Response to Reviewer 1

The manuscript by Schmitt et al. demonstrates the development and deployment of a near-infrared open-path dual-comb spectroscopy system for CO₂ (and CH₄) observation over the city of Heidelberg. The manuscript is well-written and describes the dual-comb system well. While the authors demonstrate the good precision of the system for the concentration of CO₂, the ambiguous position of CH₄ in the manuscript needs to be addressed before this manuscript can be recommended for publication.

Figure R1: Distribution of the differences between the two instruments as a function of temperature. Binning in intervals of 5 K. Bins below 270 K and above 300 K are excluded due to low statistics.

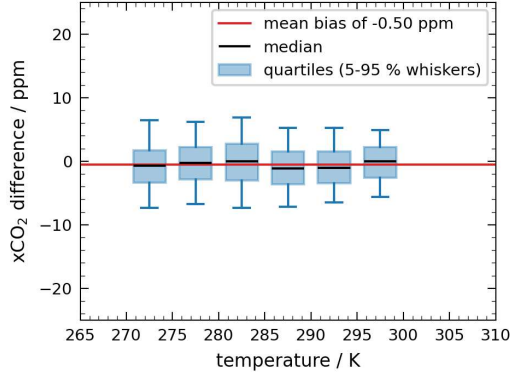
2. The comparison to the co-deployed FTIR yields a positive bias of the DCS instrument of 0.16 ppm CO₂. Since this is a major outcome in this work, further elaboration on the nature of this bias would be appropriate. For example, do the residuals of both instruments for the longest possible averaging time (thus minimal noise) show certain differences in how well absorption lines are fitted? Do both instruments fit the same absorption lines of CO₂ or could the difference be explained by line list discrepancies between the different absorption lines? And is the bias stable over the fluctuations in pressure and temperature, or is the bias a temperature effect? Particularly, an analysis of the bias over varying ambient temperature could be interesting.

Reply: There are no obvious differences in the fit residuals between the instruments, but please keep in mind that the FTIR spectra cover individual lines only with a few samples each. So a one-to-one comparison of the spectra is difficult. Both instruments fit the CO₂ absorption lines at 1.6 μm and the FTIR instrument makes use of the absorption band at 2 μm additionally. We made the description in the manuscript clearer. The bias is not a temperature effect and indeed stable over the temperature range from 270 K to 300 K that our data covers (see Fig. R1).
